**Re: Rapiscan AIT System Radiation Survey Reporting**

<b>Rapiscan</b> 2 2 1 0 0 0 ©2009 Rapiscan Security	<b>Secure 1000 Radiation Emission Measurement</b>	<b>FORM R-0646-1 (Single Pose)</b>
---	---	------------------------------------

## R-0646-1 Addendum (Documentation Errors)

**2. Radiation Leakage Measurement: Survey Table. 2**

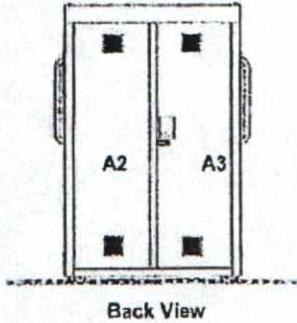
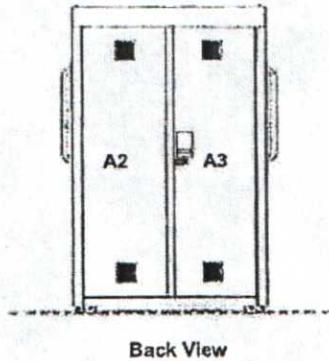
1. No value indicated for background radiation. Typical values range from 7uRem/hr to 13uRem/hr at sea level. Note: Absence of value has no adverse impact on calculations.
2. Survey is missing date of manufacture. Date confirmed from manufacturing records.
3. TABLE 2: Technician did not calculate result in Column 6 for Dose Equivalent. The correct value should be 1.8 uRem.
4. Technician did not print his name on survey report.

The service technician should attend refresher training.

The corrected data indicates this system was operating within expected parameters. No re-survey is required for this system.
